Harvey Basin Surface Water Allocation Plan

**Advice to the Minister for the Environment from the
Environmental Protection Authority under Section 16 (e) of the
Environmental Protection Act 1986**

**Environmental Protection Authority
Perth, Western Australia
Bulletin 910
November 1998**

Figure 2. Pre European and current annual stream flows (GL) in the Harvey Basin under average climatic conditions.

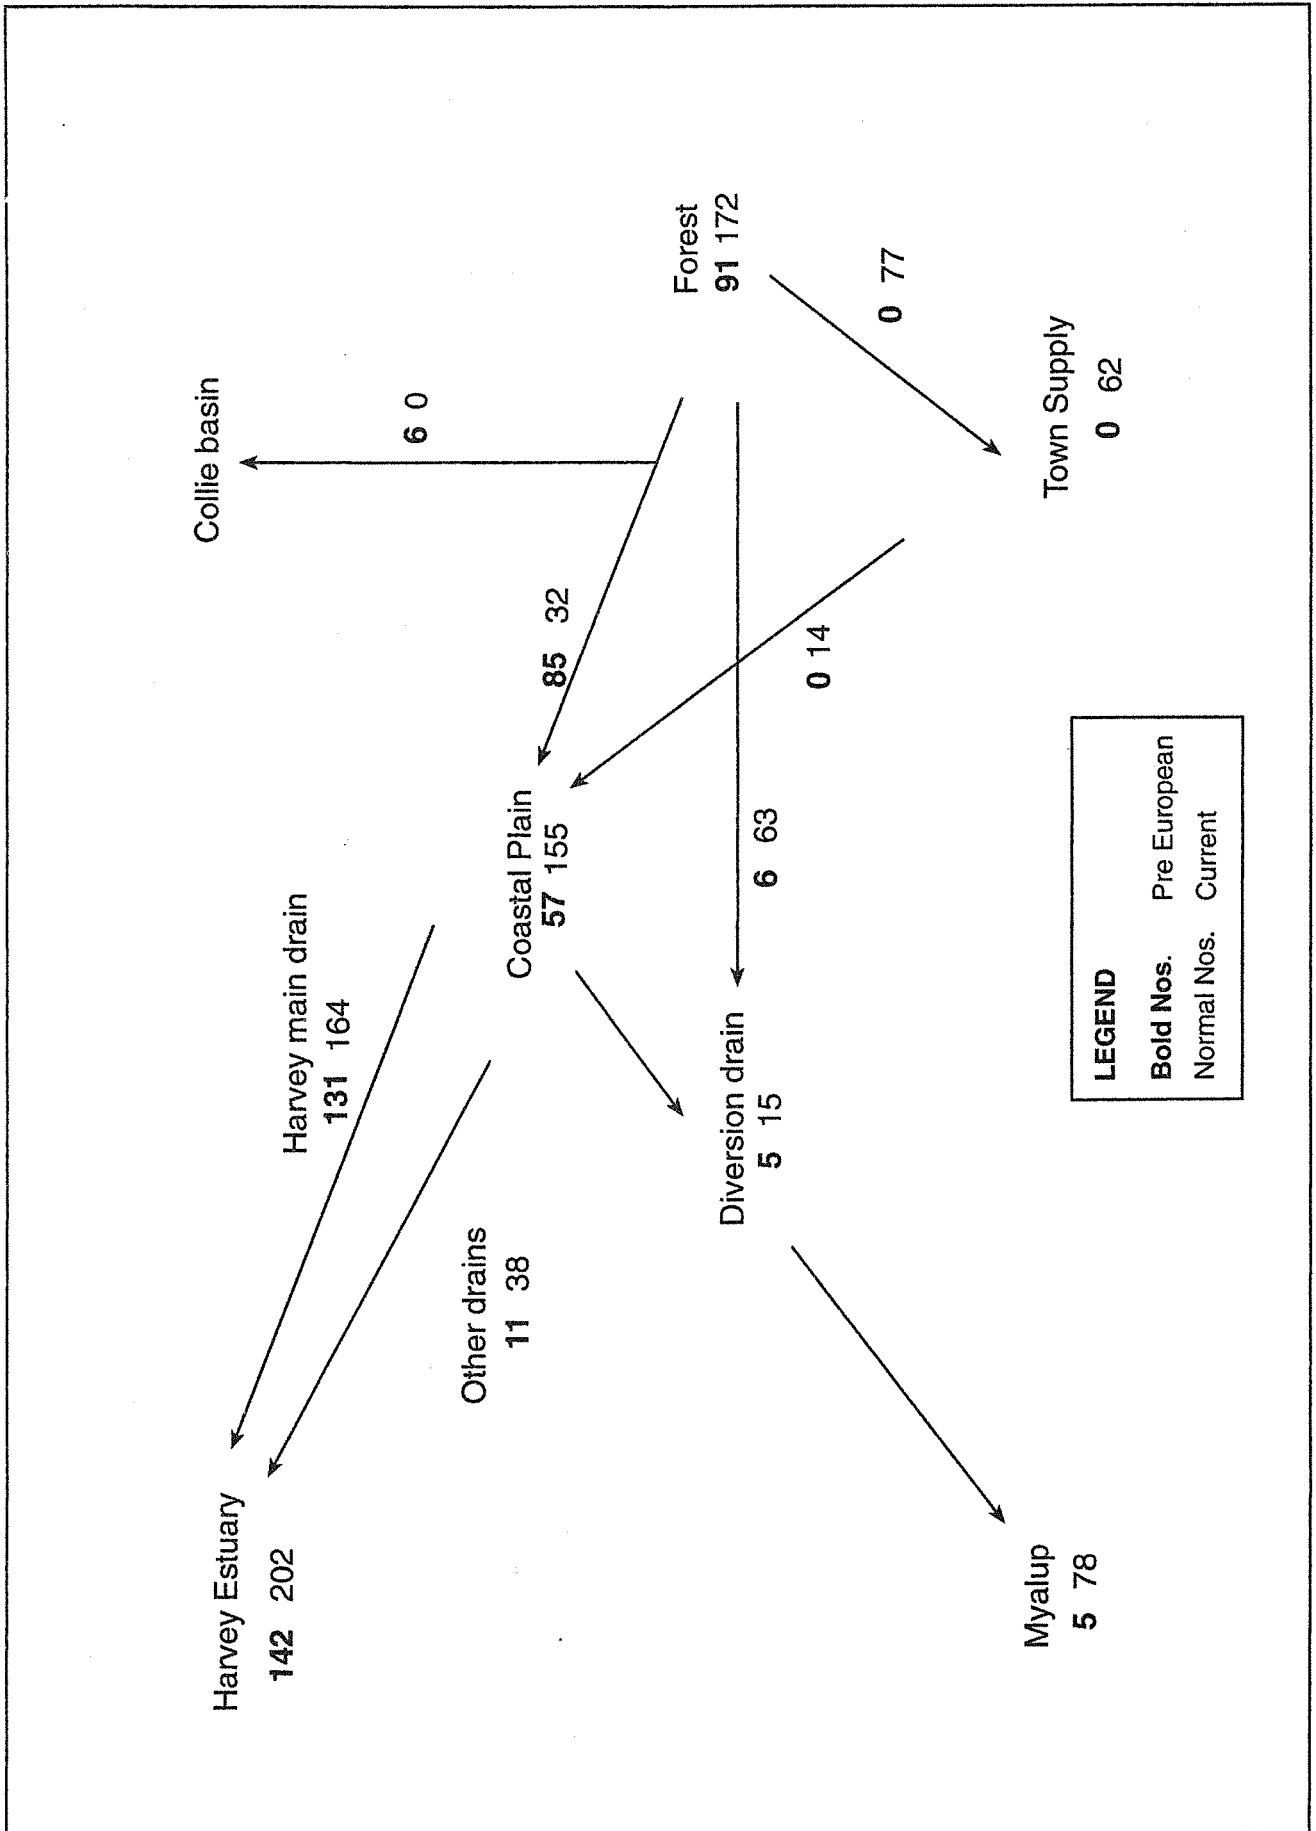
As a consequence of the drainage system and impacts of agriculture on the Harvey river system downstream of the current weir, few ecological values of the river on the coastal plain remain. Discharges from the coastal plain (including irrigation returns) have increased threefold since European settlement, resulting in water in excess of existing ecological water requirements (Figure 2).

The provision of water to the environment as proposed by the WRC is considered adequate to accommodate the ecological values remaining downstream, and deprivation of water to the environment will not occur as a result of allocation of water to consumptive use from the water resource of the Harvey River.

1. A program should be established to monitor the efficacy of EWPs of riparian vegetation and aquatic fauna that may be affected by the diversion of surface water from the Harvey River.

Figure 3 a-b. Development options for the Harvey Basin water resource.

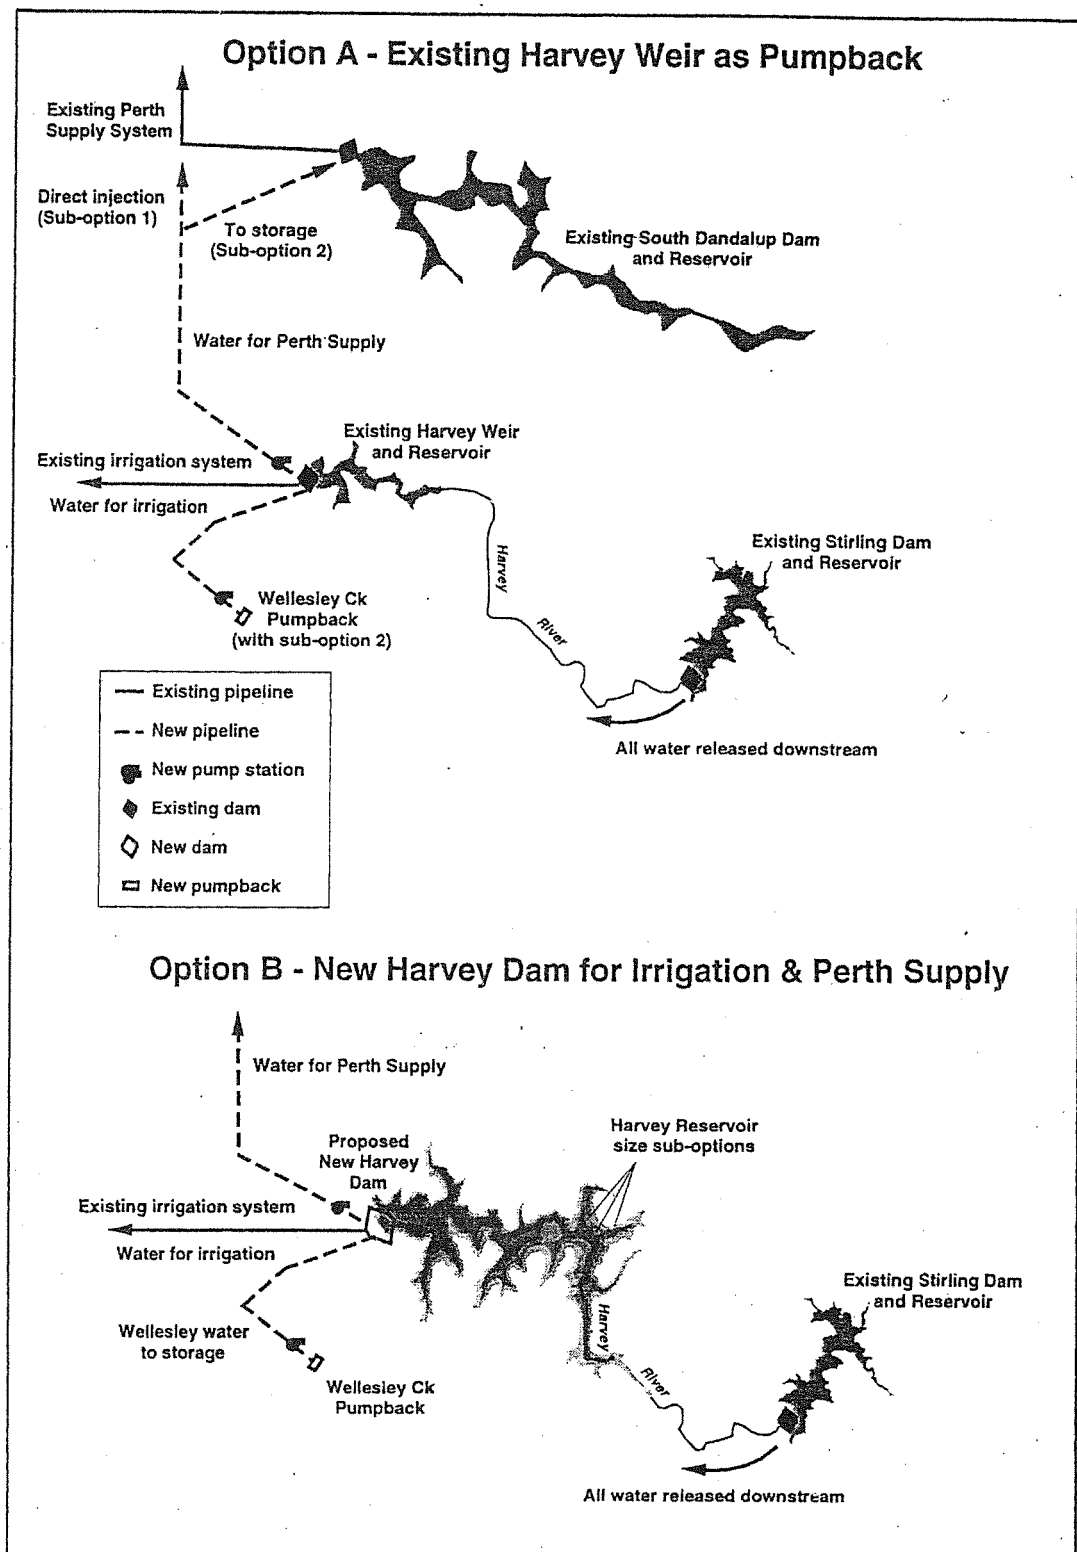
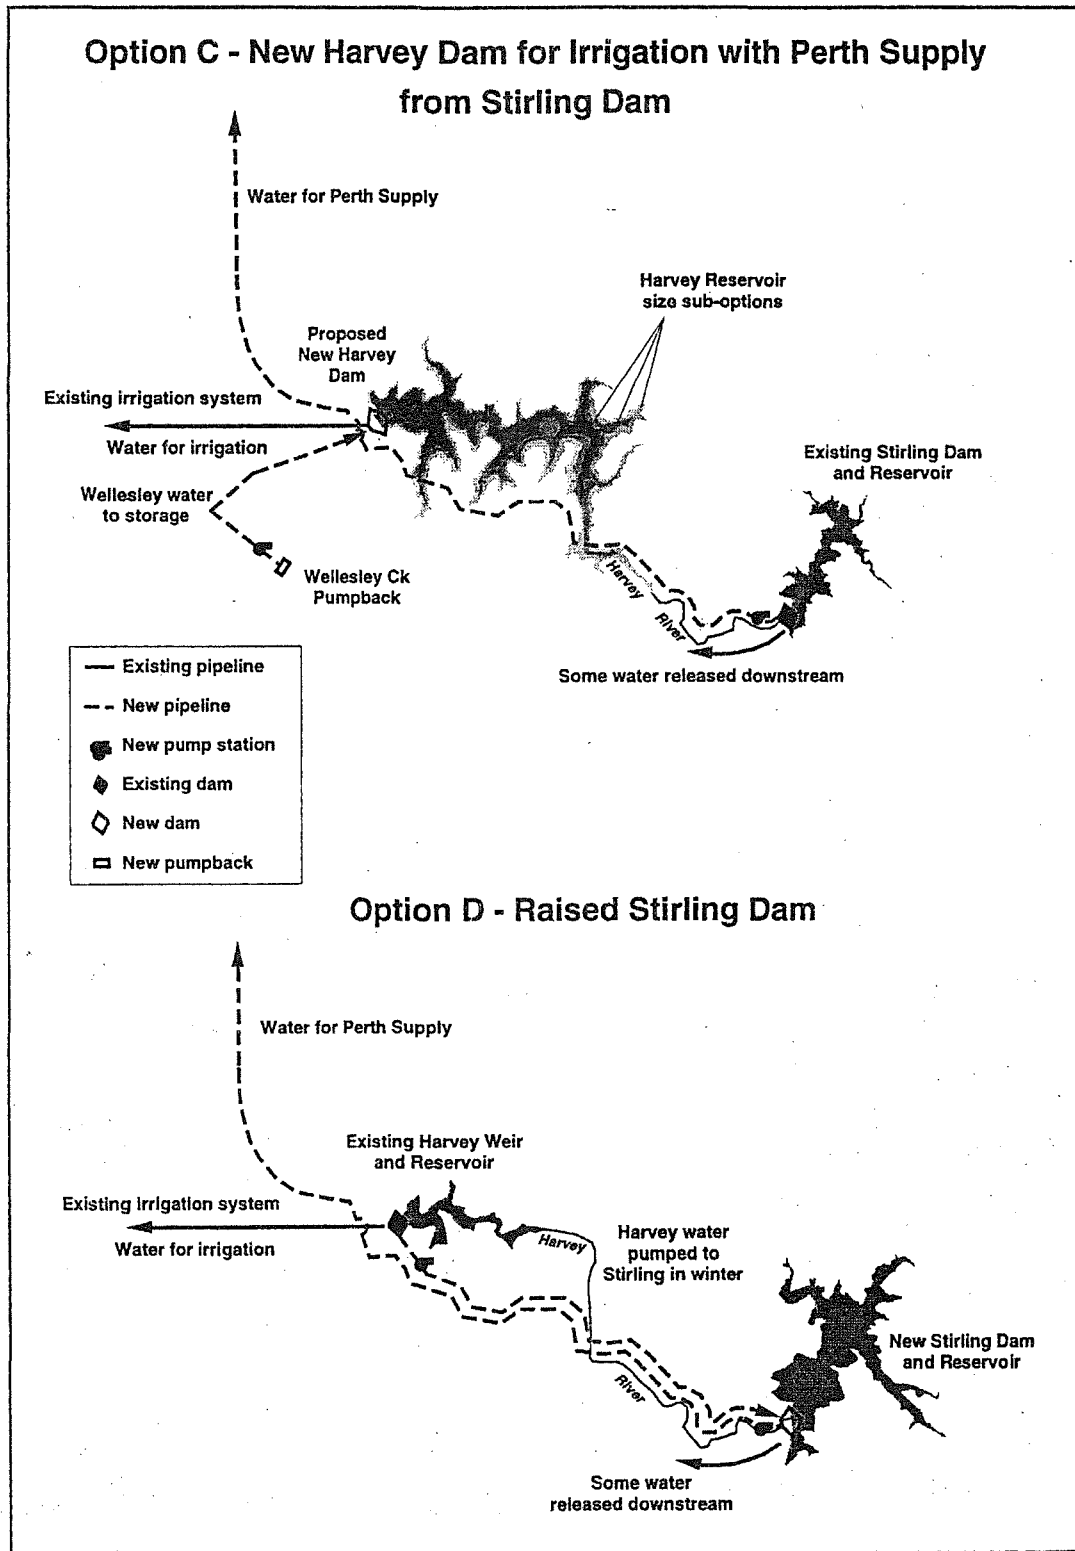
Consideration was given to dams with a wall height of 70m, 80m or 90m full supply level under Options B and C. Discussion of impacts of a dam in this report relate predominantly to a dam with a full supply level (FSL) of 80m. After consideration of a number of aspects, WRC has indicated that a 78m FSL dam is the preferred scenario. Consequently, impacts arising from a dam of 80m may be conservative.

The environmental and social issues associated with the development of a new Harvey Dam of approximately 80m FSL as included under Options B and C are discussed in Sections 3.3 to 3.6 of this report.

Figure 4. Areas of remnant vegetation in the surrounds of a new Harvey Dam.

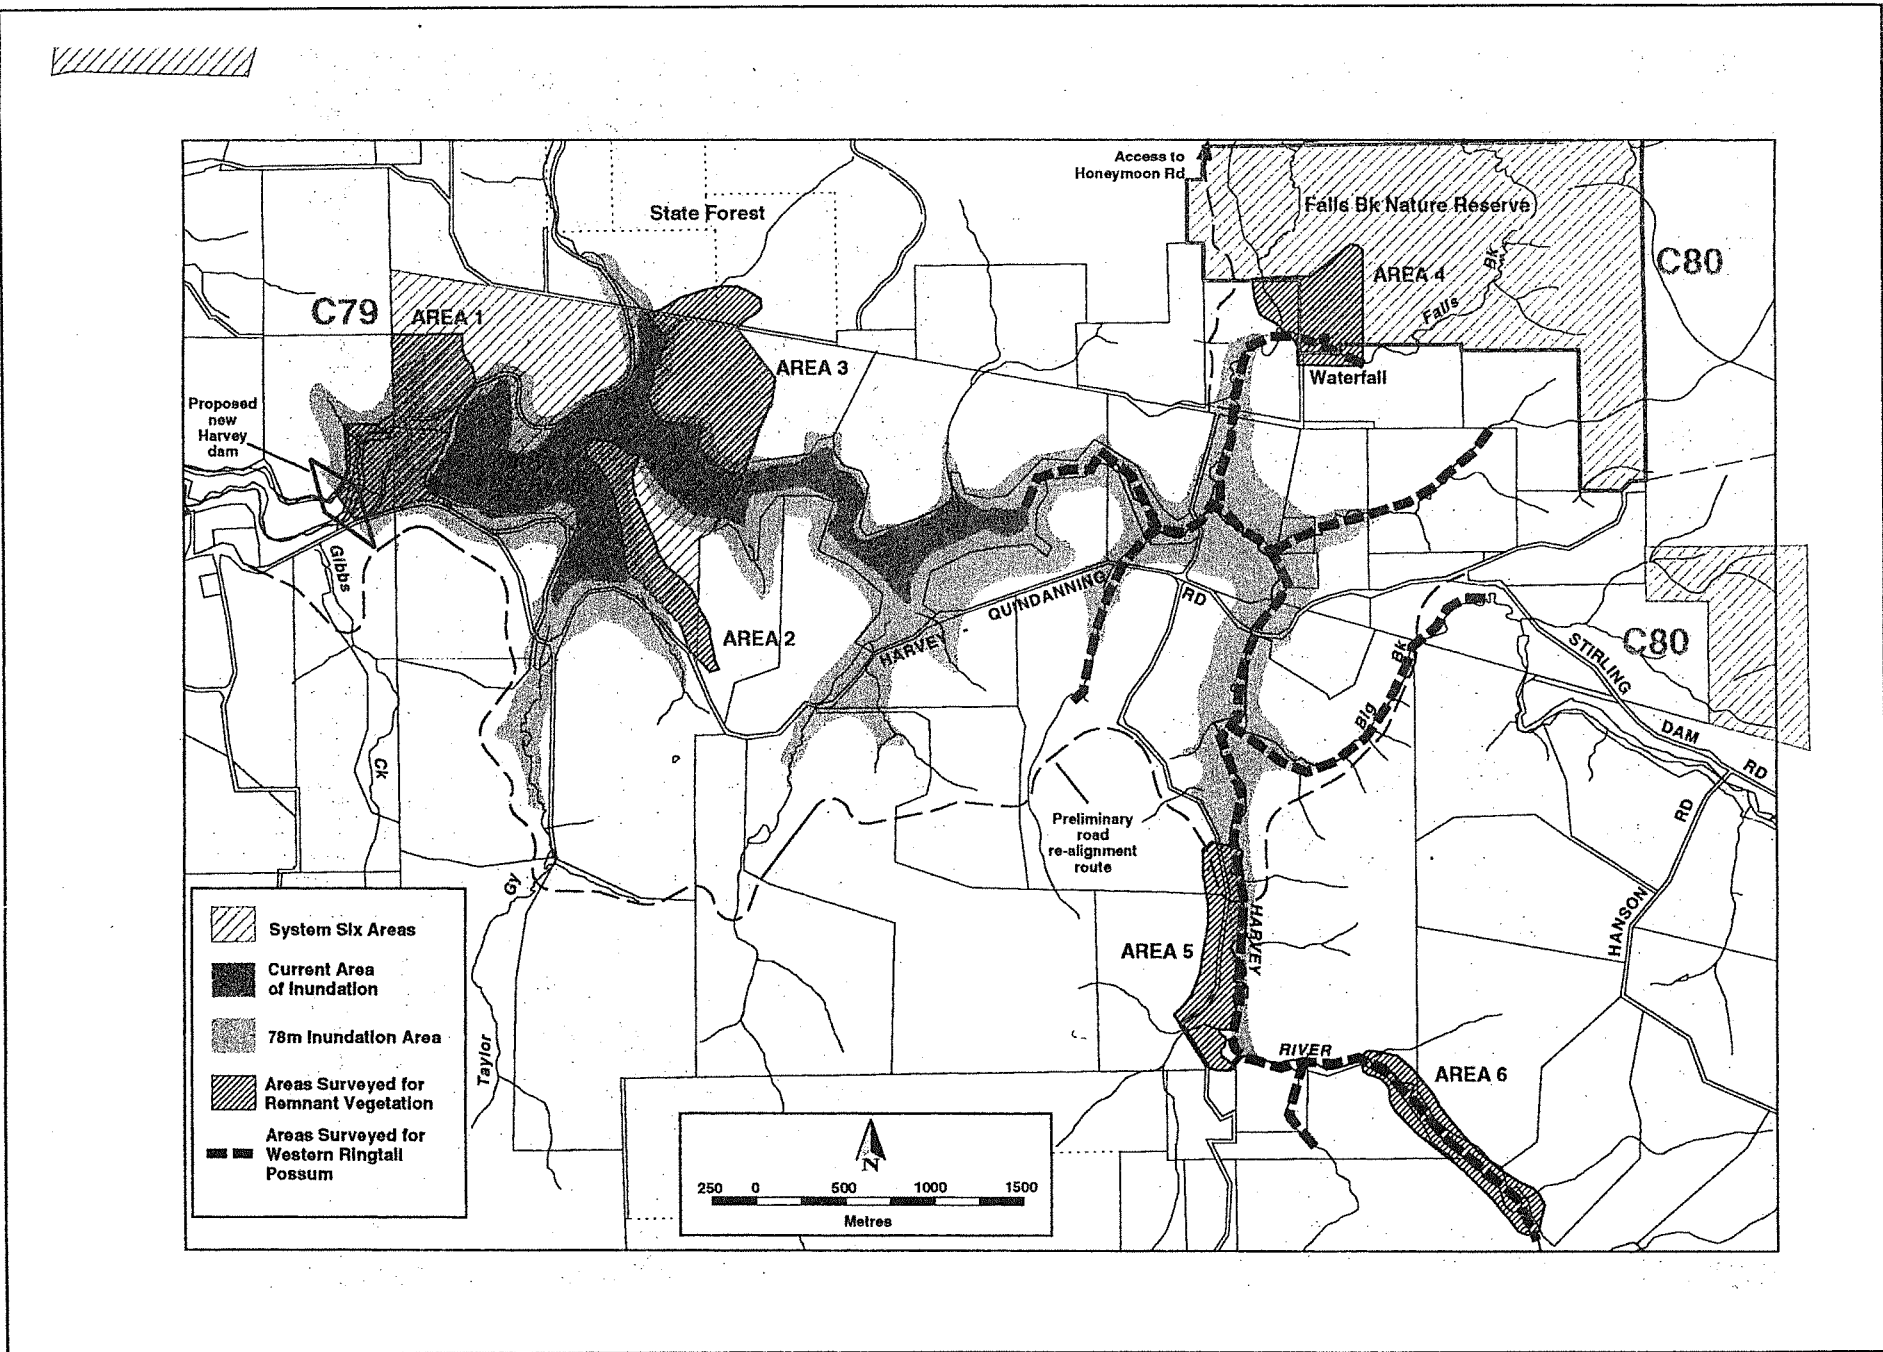
The vegetation complex that will be the most significantly impacted by a new Harvey Dam is Lowdon (75ha). This complex occurs on fertile soils and has been targeted for clearing for agriculture in the past. Both Lowdon and Darling Scarp vegetation complexes are poorly represented in conservation reserves. The Lowdon complex is relatively rare in general, and although poorly reserved is well represented in State Forest. The Lowdon and Darling complexes to the west of the inundation area have been disturbed by clearing and exotic pastures and plantations. Both the Helena and the Darling complexes retain high proportions of their original extent.

1. the WRC recommends that the full supply level of a new Harvey Dam be no greater than 78m so as not to impact the nature conservation values of Falls Brook Nature Reserve;
2. the WRC recommends a developer of a new Harvey dam prepare a management plan for the Western Ringtail Possum;
3. the WRC requires a vegetation protection plan for remnant vegetation in the vicinity of a new Harvey dam;
4. the WRC would require compliance with the above recommendations as a pre-condition to obtaining a take and use licence for the Harvey River Hills water resource; and

2. Vegetation survey results should be analysed at plant community level, and analysis/comment provided to enable comparison of the vegetation at this level to areas outside of the study area.
